**From:** Byers, Harris <Harris.Byers@stantec.com>  
**Sent:** Friday, March 22, 2024 12:17 PM  
**To:** Beggs, Tauren R - DNR  
**Subject:** Response to WDNR Comments on River Landing  
**Attachments:** River Landing Response Letter.pdf

March 18, 2024

**Reference: Response to WDNR Comments on the Ch. NR 716 Site Investigation Addendum  
Proposed River Landing Redevelopment in the River Point District  
Manitowoc, Wisconsin  
BRRTS ID: 02-36-593784**

Figure No. 1  
 Title: Sample Locations and Soil Impacts  
 Client/Project: Site Investigation Project Area  
 River Point District  
 City of Manitowoc  
 0 25 50 Feet  
 Prepared by HLB on 5/8/2023

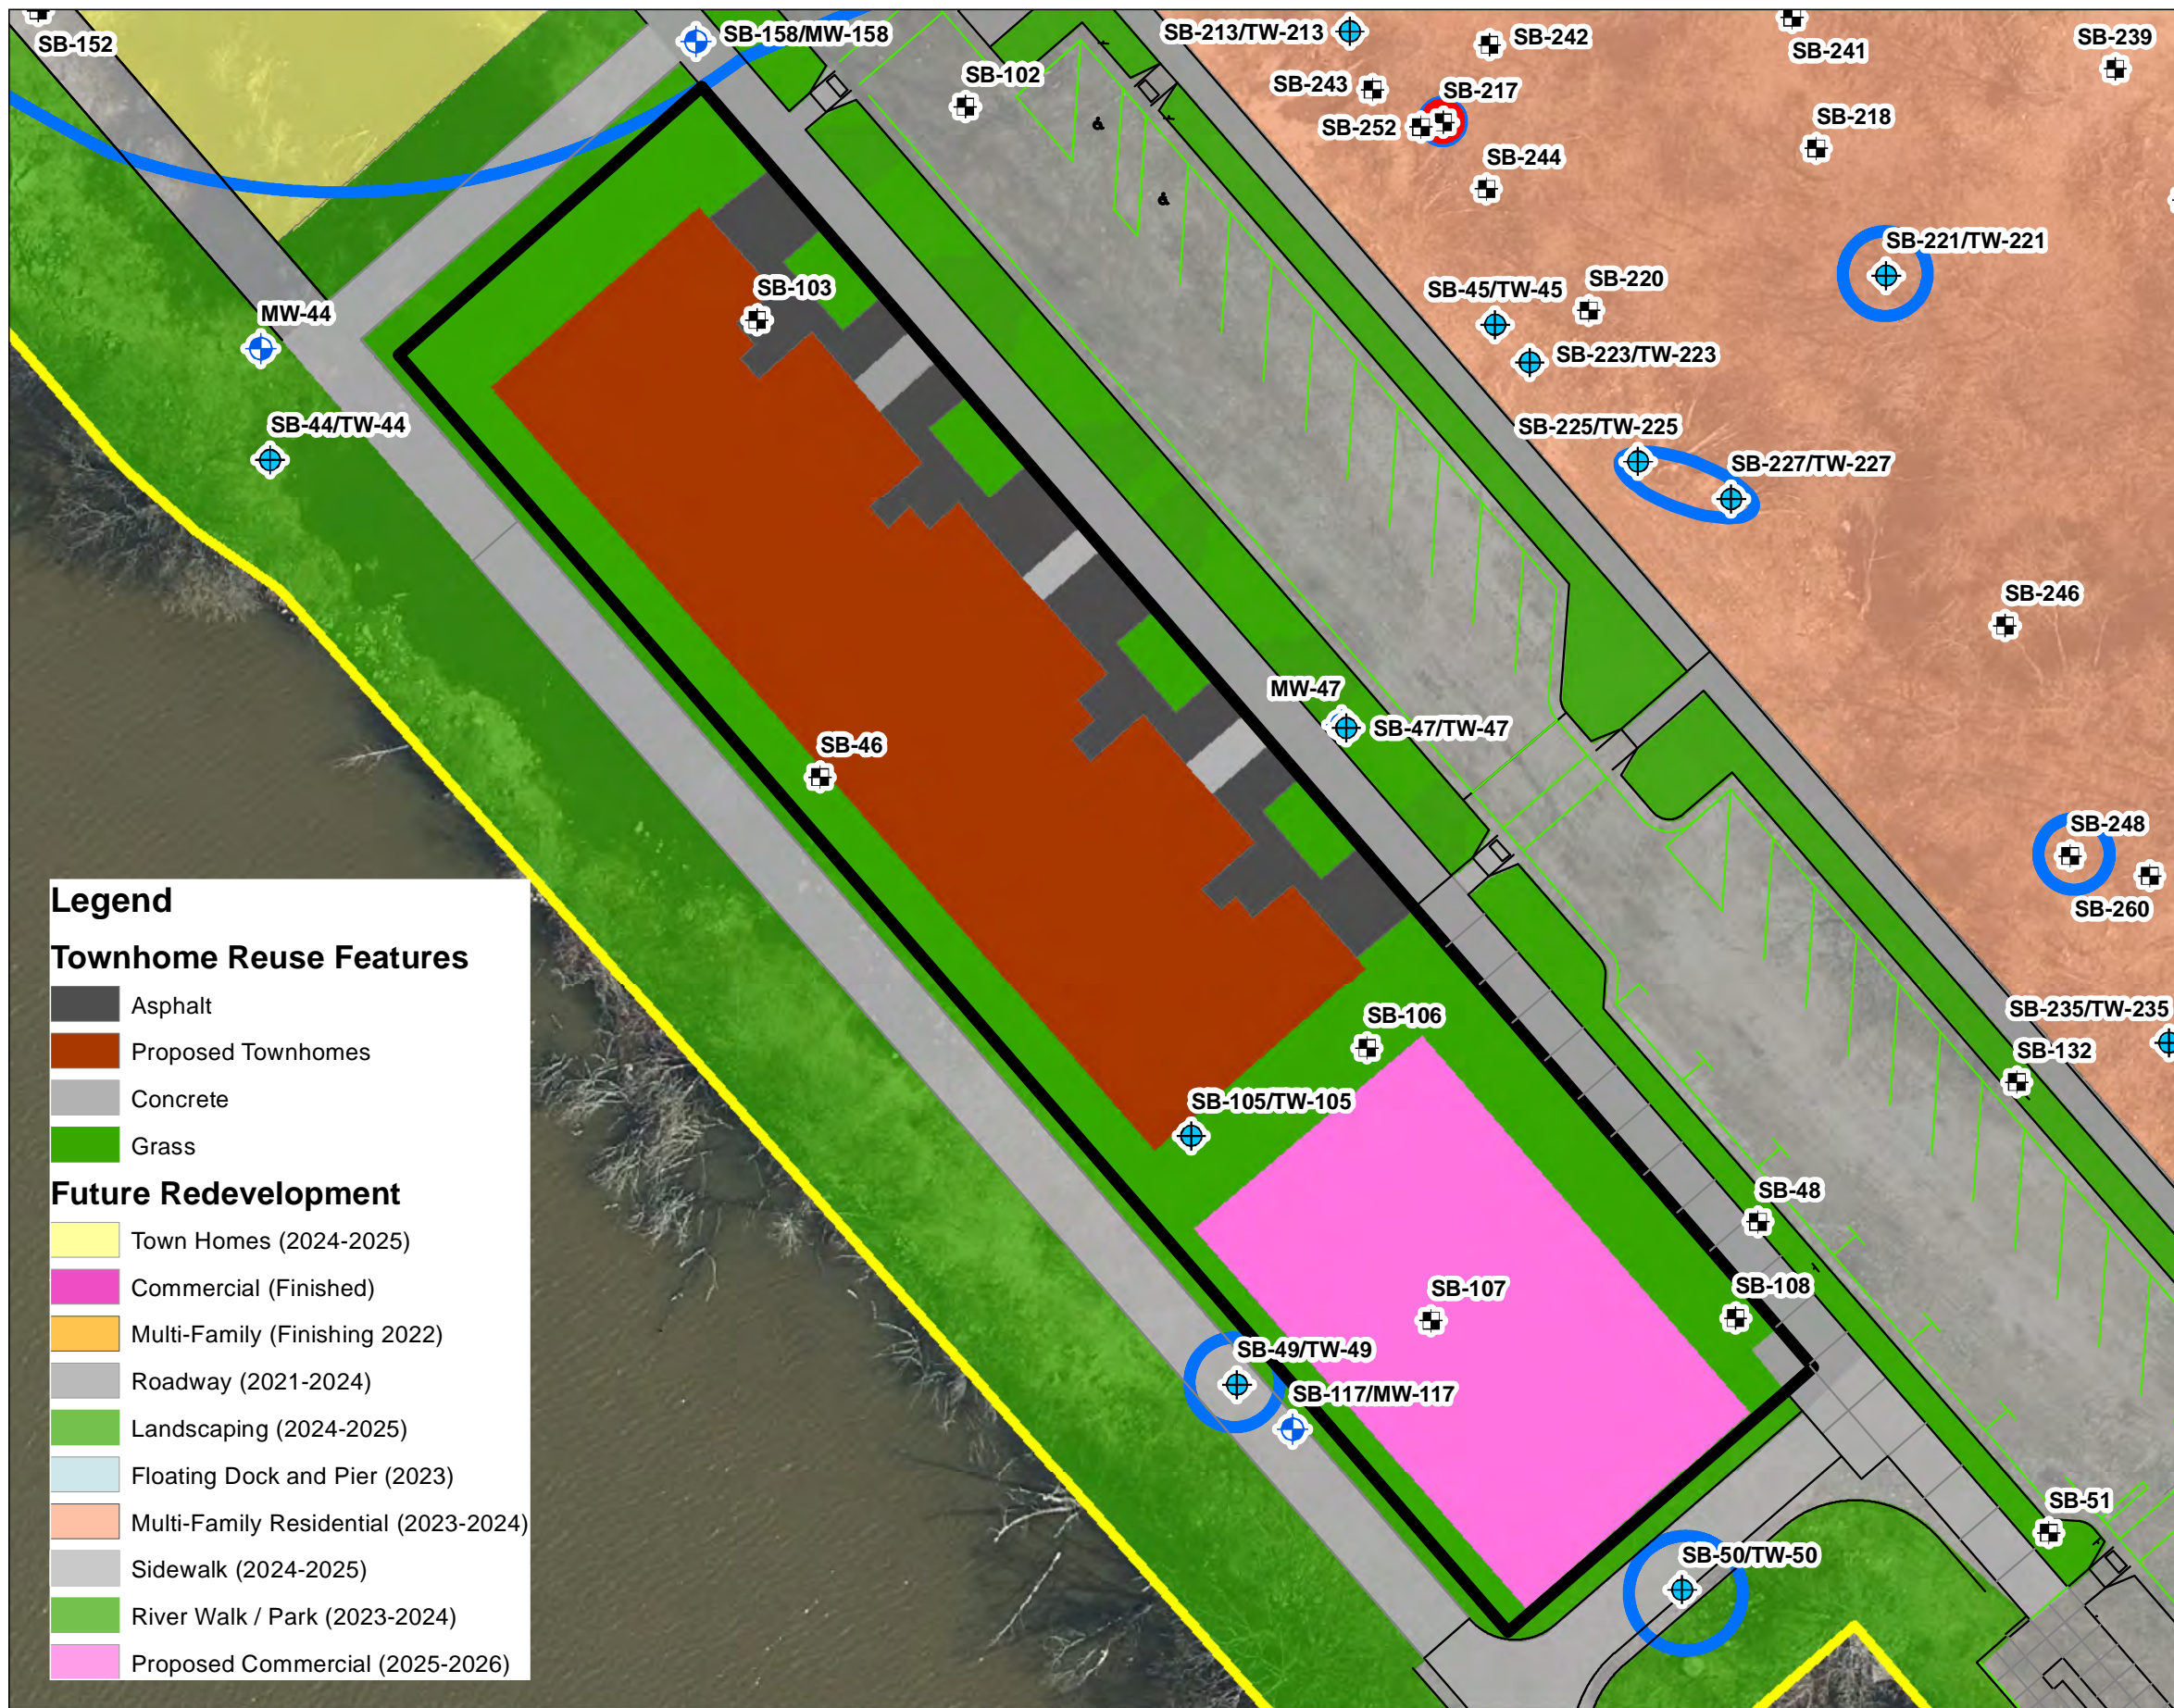
**Comment 1.** *For sediment, please provide additional justification as to why a sediment investigation is not warranted. Please refer to the factors to consider (such as overland flow, direct conduits like pipes, sewer lines, or outfalls) as outlined in the DNR Guidance Documents Guidance: When should a site investigation enter surface water?, RR-0117 and Guidance on Addressing Contaminated Sediment Sites in Wisconsin, RR-0124.*

**Comment 2.** *For vapor, please provide a screening for chlorinated volatile organic compounds (CVOCs), due to potential (primarily from soil screening criteria) for impact to this site from adjacent Lot 3 – Former Turntable/Roundhouse area. You can utilize data from the closed case WCL – Turntable Former Roundhouse, BRRTS # 02-36-176478 and the more recent data collected in the Lot 3 area associated with the case RR Turntable (Former), BRRTS # 02-36-593783 to provide your justification. Please refer to Section 3.4 of DNR’s guidance document Addressing Vapor Intrusion at Remediation & Redevelopment Sites in Wisconsin, RR-800, for the CVOC screening criteria.*

**Property Boundary.** As illustrated on **Figure 1** and **Figure 2**, the Property does not extend to the shoreline. Instead, the City of Manitowoc will retain ownership of the shoreline and the area between the shoreline and the Property as a public rights of way. As such, impacted historic granular fill at the Property is not likely to be transported to the River through overland flow. Please note, the City recently constructed an engineered barrier along the shoreline of the Manitowoc River to prevent potential migration/transport of soil impacts into the River.

Soil. As illustrated on **Figure 1**, the proposed buildings are not over nor within 100 feet of chlorinated solvent impacted soil.
